GROUP	MODEL
Voluntary Service Campaign	2022-2023MY Telluride (ON)
NUMBER	DATE
SC254 (Rev 1, 04/18/2023)	January 2023

DRIVE BELT INSPECTION/REPLACEMENT (SC254)

This bulletin has been revised to include additional information. New/revised sections of this bulletin are indicated by a black bar in the margin area.

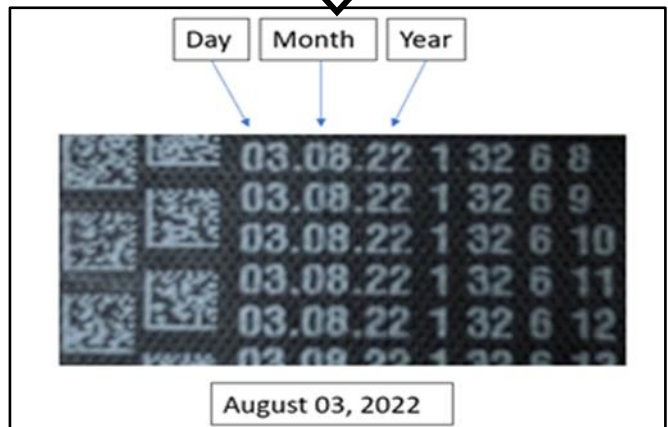
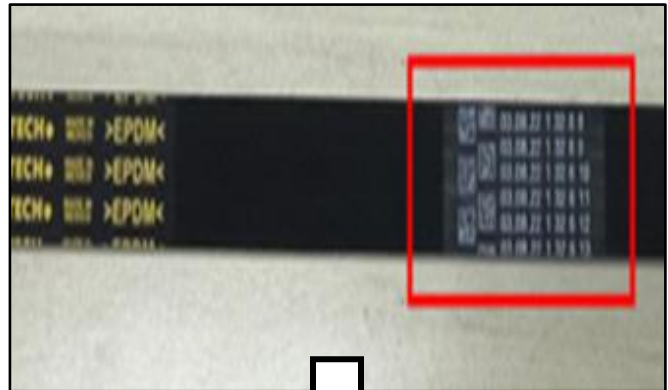
1. Open the hood.
2. Using the SST Crank Rotator Wrench (KQ231 2T102QQK) or equivalent tool, slowly rotate the crankshaft pulley clockwise until the **lot date** on the drive belt (A) is visible.

3. Record the drive belt manufacturing date as shown on the belt.

Note: The lot date is formatted as follows:

DAY . MONTH . YEAR

4. If the manufacturer date is between **(NG)**:
 - **21.08.21 to 12.11.21** (August 21, 2021 to November 12, 2021) or
 - **between 29.03.22 to 25.05.22** (March 29, 2022 to May 25, 2022), then replace the drive belt with the new part by referring to "Maintenance → Drive Belt → Repair procedures" in the applicable Shop Manual on KGIS.

If the manufacturer date is between **(OK)**:

- **13.11.21 to 28.03.22** (November 13, 2021 to March 28, 2022) or
- **after 26.05.22** (May 26, 2022), then no further action is required.
